Review of US EPA's "Draft Investigation of Ground Water Contamination near Pavillion, Wyoming"

Halliburton Energy Services, Inc.
P.O. Box 42806
Houston, TX 77242-2806

Gradient
20 University Road
Cambridge, MA 02138

June 25, 2012

Figure 2.1 Regional Depth Trend in Groundwater Data Indicates Downward Flow

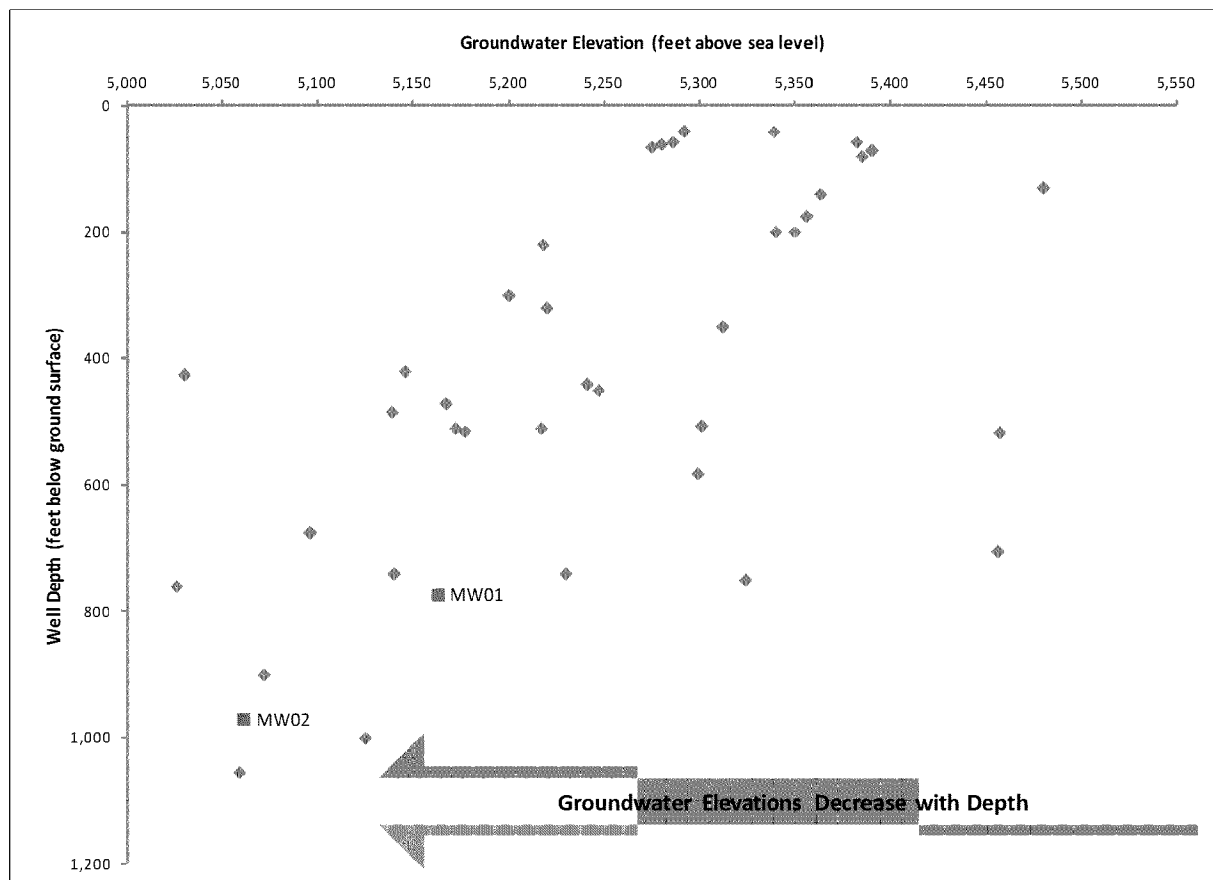
Another approach for determining the vertical direction of groundwater flow is to plot groundwater elevations from wells within a region against well depths. If groundwater elevations decrease with depth, this is an indication that flow is downward. We undertook such an analysis with recent groundwater data, which is shown in Figure 2.1 (data from James Gores and Associates, 2011). This plot shows that groundwater elevation decreases with depth in the Pavillion area, indicating that groundwater flow is downward. Note also that the water levels for MW01 and MW02 plotted on Figure 2.1 are also consistent with a downward regional hydraulic gradient.

Figure 3.1 Water Level Measurements in MW01 and MW02

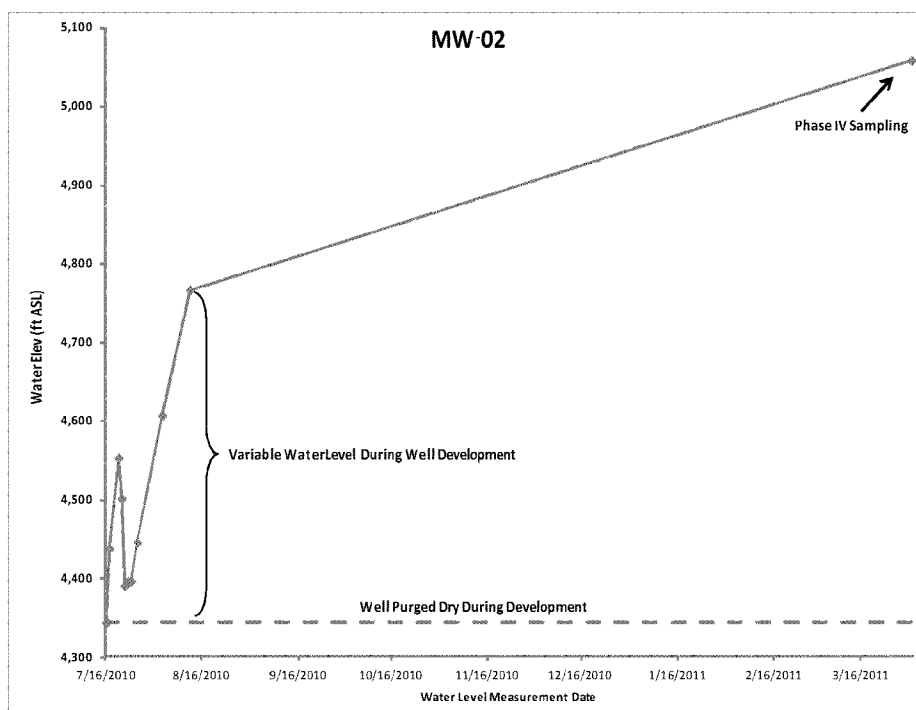
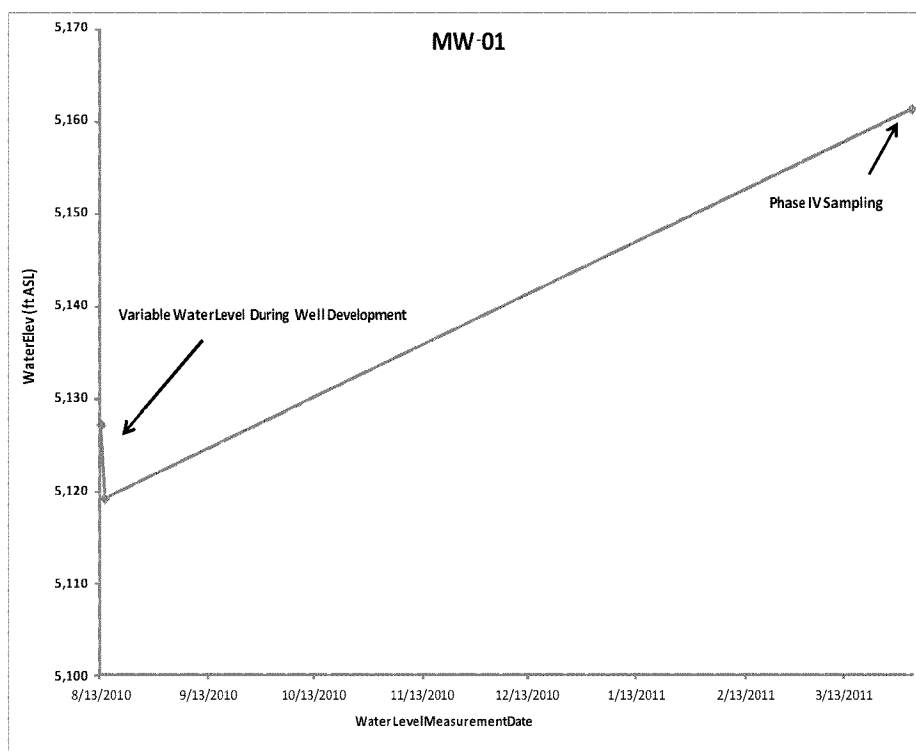
At MW01, a sufficient volume of water was removed (10,960 gallons) and a turbidity reading below 10 NTU was achieved; however, temperature, pH, and conductivity were not recorded and may not have stabilized. At MW02, less than two (2) well volumes were removed before well development was halted due to methane accumulation in the well. The slow recharge rate at this location (*e.g.*, as shown in Figure 3.1, approximately one month after well development in 2010, the water level in the well was still 89 meters (293 feet) below the static water level measured in March 2011) is a potential indicator of inadequate well development (including an indication of clogged well screen), or of a zone that is incapable of delivering enough water to qualify as a USDW, or a combination of both. Moreover, the Work Plan-established turbidity target was not reached, and the other required parameters were not recorded.

At both deep monitoring wells, water jetting (injection of water into the well at the screened interval) was used to aid well development. No analytical samples of the water were collected, and thus the quality of the water added to the wells is unknown, which draws into question the reliability of sampling results from MW01 and MW02. Inadequate well development at MW02 renders the data collected from this well and the conclusions drawn from these data (*e.g.*, pH, potassium, chloride) unreliable.

Figure 3.2 Field Parameters Measured Prior to Sample Collection at MW02 (Phase III)

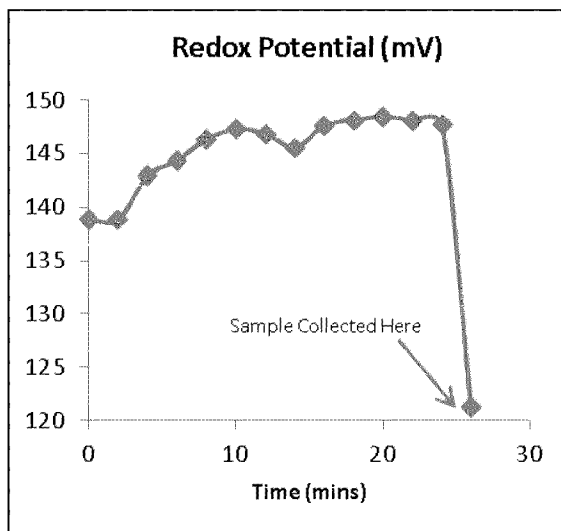
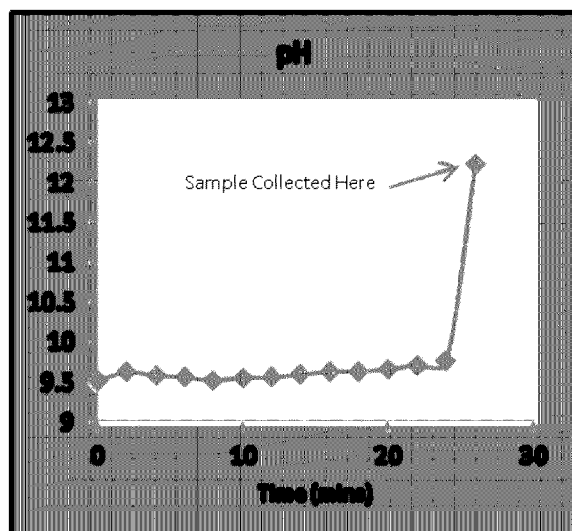
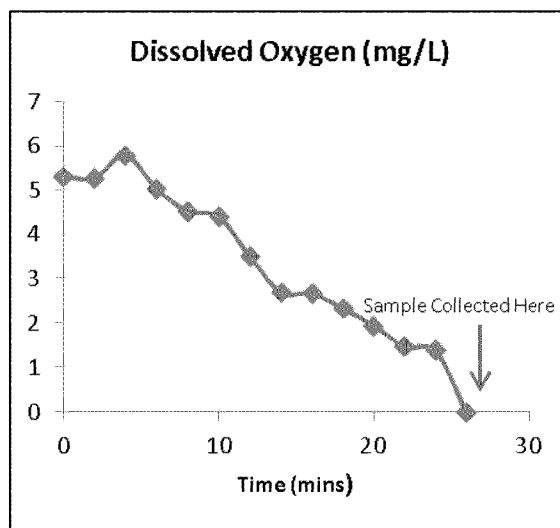
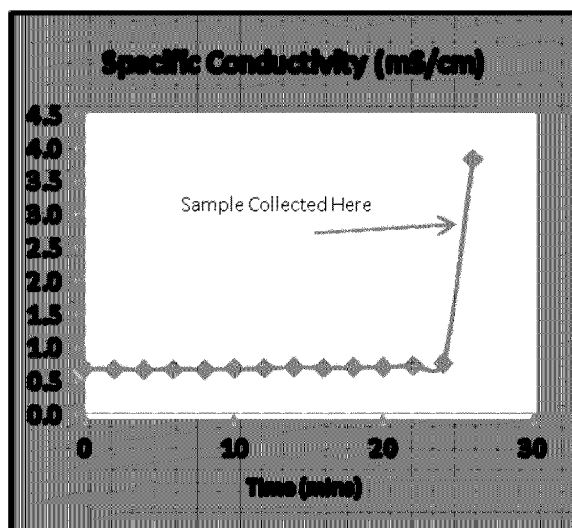
However, US EPA collected groundwater samples at the deep monitoring wells during Phase III of the Study, when field parameters had not stabilized (Table 3.1 and Figure 3.2). In fact, the field monitoring data reported in field logs demonstrate that water with dramatically different geochemistry had entered well MW02 immediately prior to sample collection (Figure 3.2) and demonstrated significant violations of the stabilization criteria defined in the Work Plan (Table 3.1). These data clearly demonstrate that stabilization had not been achieved prior to sample collection and that additional well development was needed at MW02. US EPA not only apparently ignored these data in the field, but it failed to present or acknowledge these data in its report (US EPA, 2011).

Figure 4.1 Comparison of Hydrocarbon Distributions in Gas Condensate Sample PGPP06 and Deep Monitoring Well MW02

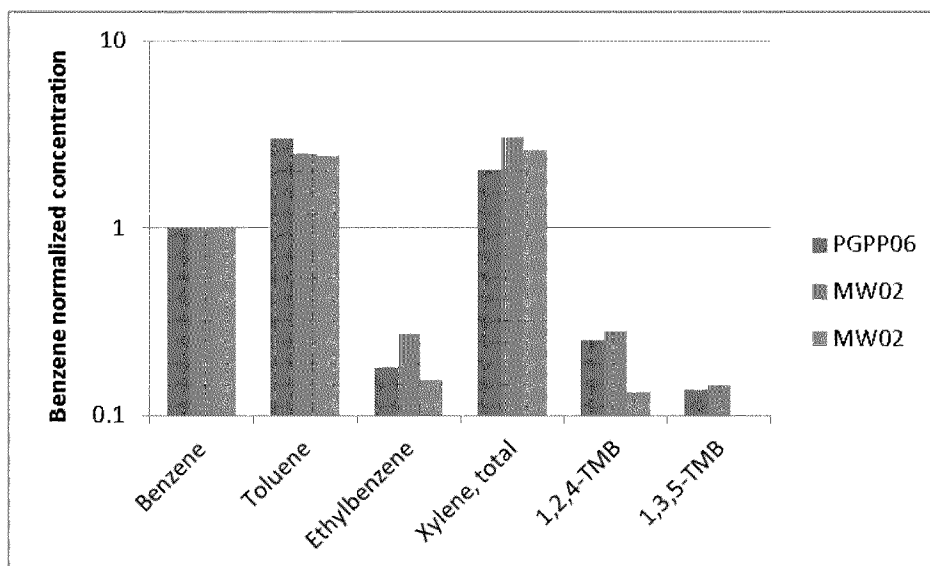
One of US EPA's other lines of reasoning is that petroleum hydrocarbons (BTEX, trimethylbenzenes, naphthalene, GRO, and DRO) were detected in one or both of the deep monitoring wells (US EPA, 2011, p. 35). The detection of many constituents is questionable, however, given the contamination of field blanks (Sections 3.4 and 4.6). Thus, US EPA's data are not reliable for drawing conclusions about the presence or migration of contaminants. However, even if one assumes that the data are valid, the data would indicate that hydrocarbons found in the deep monitoring wells are consistent with those associated with natural gas, rather than providing evidence of hydraulic fracturing as suggested in the Study.

Figure 4.2 Concentrations of Diesel Range Organics (DRO) versus Depth

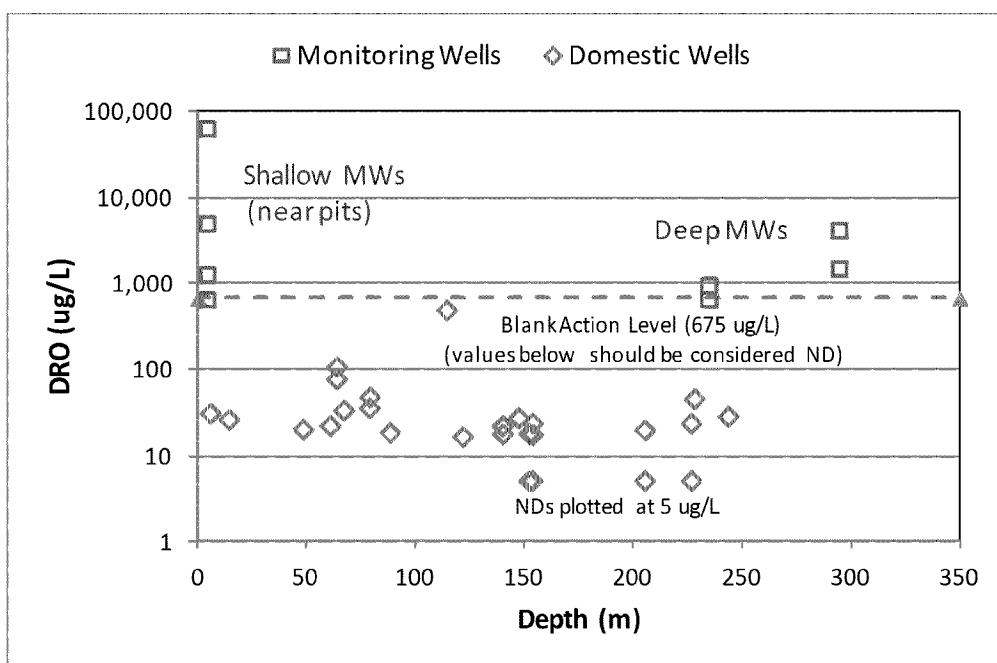
- The distribution of DROs in domestic wells is consistent with the natural presence of hydrocarbons and heterogeneity in the study area or an artifact of the poor sampling practices utilized in the Study (see Section 3). If there were a contaminant source present at depth and contaminated groundwater was moving upward, then concentrations should exhibit an increasing trend with depth. However, the DRO concentrations do not increase with depth (Figure 4.2). It should also be emphasized that, due to DRO in QA (blank) samples, the DRO results for the drinking water samples are all below the Blank Action Level and should be considered non-detects (see Section 3.4).

Figure 4.4 Methane in Drinking Water Wells as a Function of Proximity to Gas Wells

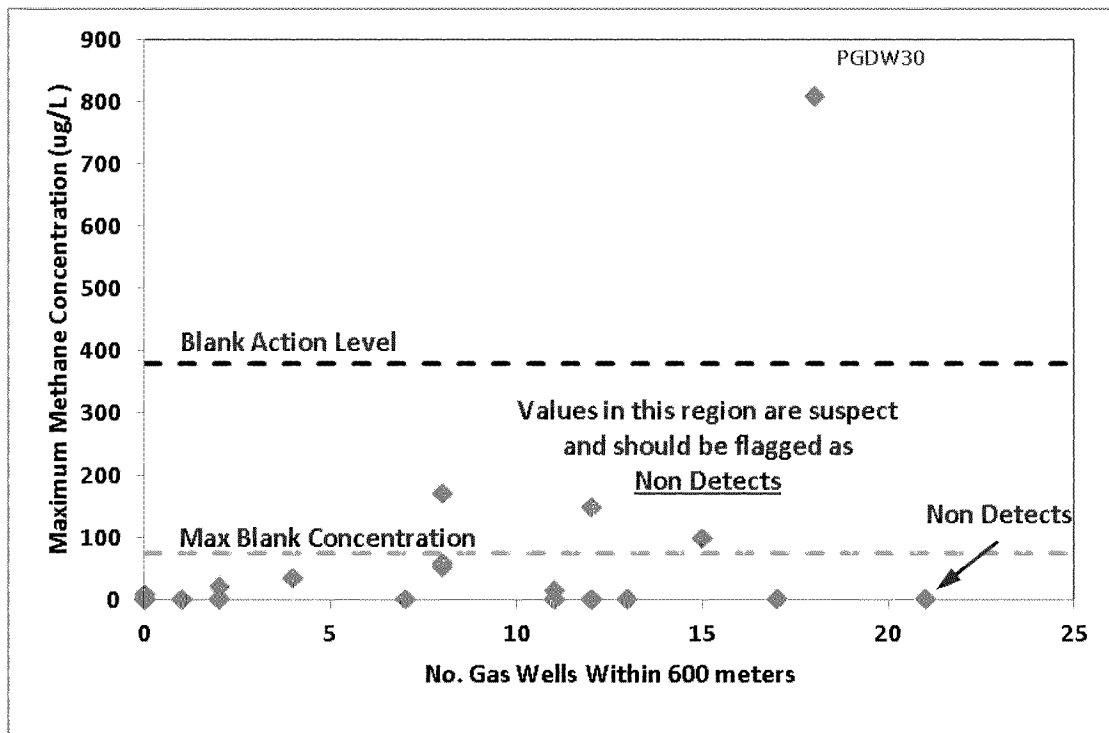
US EPA suggests that the methane concentration in domestic well samples is generally higher for those wells that are in proximity to gas production wells (US EPA, 2011, Figure 18c). That depiction of the methane data is misleading.

We have plotted the methane data for the domestic wells as a function of the number of gas production wells located within 600 meters (the same proximity used by US EPA, 2011, in Figure 18c). As seen in Figure 4.4, below, there is no discernible relationship between the methane concentrations in drinking water wells and the numbers of gas production wells within 600 meters. As the number of proximate gas wells increases, methane is just as likely to be non-detectable as it is to be detected. This result is not consistent with the hypothesis that natural gas production (or HF activities) have enhanced methane migration. If that were true, one would expect to see a clear relationship between higher methane concentrations *versus* the intensity of gas production and HF activities; there is no such relationship.

Figure 4.6 Methane Concentration in Domestic Wells versus Well Depth

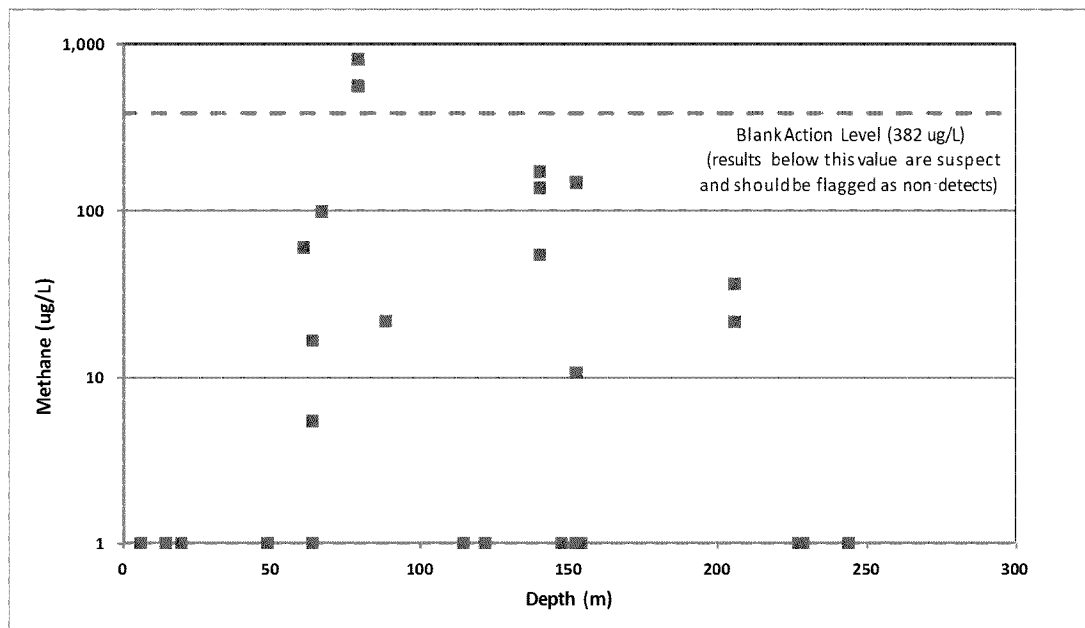
In addition, if methane were being released as a result of HF activities, as asserted by US EPA, one could also expect to see increasing methane concentrations with depth, where wells are in closer proximity to the gas production zones. As shown in Figure 4.6, there is no correlation between methane concentration and depth. In fact, if there is any pattern in the methane concentrations in the domestic wells at all, there is perhaps a slight tendency for higher methane concentrations in shallower wells than deeper wells. This pattern is inconsistent with the hypothesis that HF activities (*i.e.*, "deep source terms") are contributing to the methane concentrations in domestic wells.

Figure 4.7 Ratio of Methane to Ethane Plus Propane [$C_1/(C_2+C_3)$] versus $\delta^{13}CH_4$ for Domestic Wells and Deep Monitoring Wells

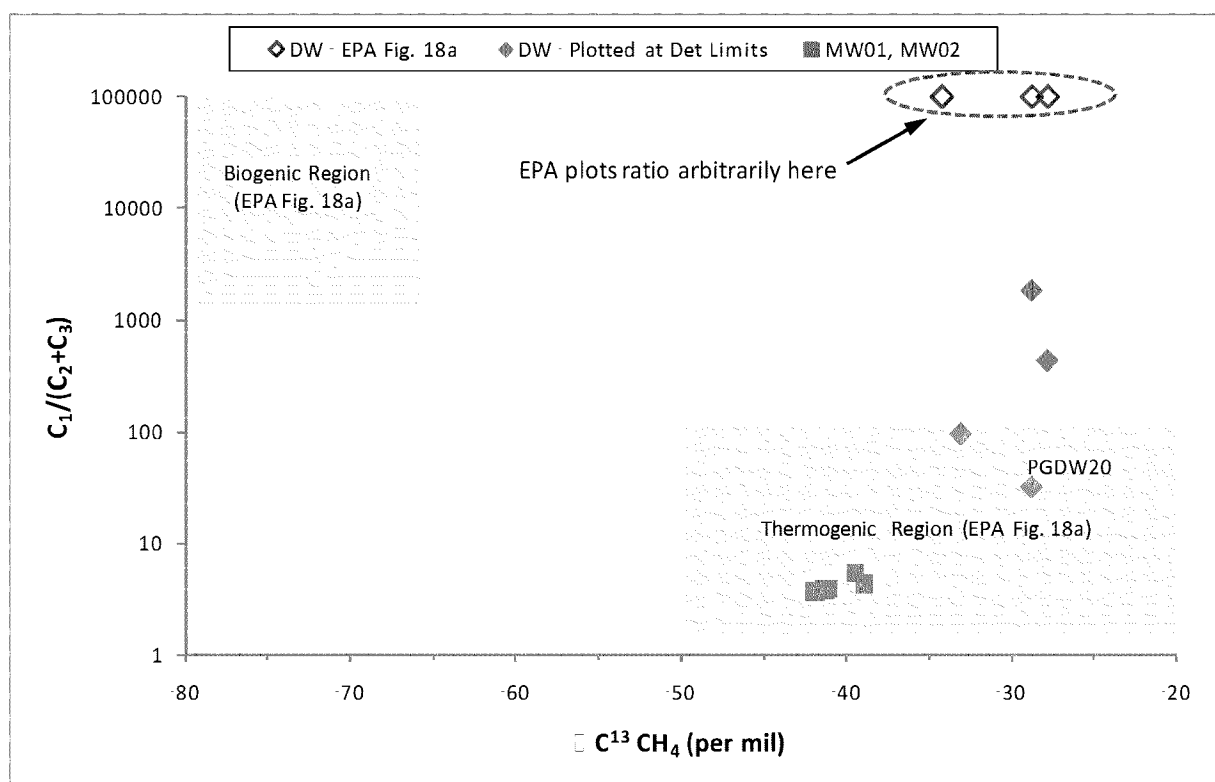
- Contrary to the claim in the Study, the interpretation is based on the sample results from only *three* domestic wells (PGDW20, PGDW30, and PGDW32), not four as the Study asserts; US EPA double counts two rounds of sampling from PGDW30.
- Of these wells, PGDW32 had no detectable methane in the Phase IV sampling, and only low levels in previous phases (21.4 $\mu\text{g/L}$ in Phase I and 36.3 $\mu\text{g/L}$ in Phase II). This draws into question whether methane is reliably present in this well, especially given the consistent detection of methane in blank samples. As discussed previously in Section 3.4 and in more detail below (in

- Neither PGDW30 nor PGDW32 had detectable ethane (C_2) or propane (C_3). Therefore, the ratio of $C_1/(C_2+C_3)$ is undefined. In Figure 18a of its report, US EPA arbitrarily plots this ratio as 100,000, giving the artificial and misleading appearance that it was significantly different than the ratios plotted for the "thermogenic" region.²⁹ Figure 4.7 below re-plots these data using the detection limits to calculate the $C_1/(C_2+C_3)$ ratio. This shows that the methane in PGDW30 and PGDW32 is primarily thermogenic in origin with small amounts of oxidation, as would be expected for groundwater overlying a gas-bearing region. These data do not support US EPA's implication of enhanced migration due to HF activities.

- PGDW20 (140.2 m bgs), which is plotted in Figure 18a in the "thermogenic" region, is 65.5 meters (215 feet) shallower than PGDW32 (205.7 m bgs). Thus, this well does not exhibit a pattern of "dispersion and degradation with upward migration" as hypothesized.
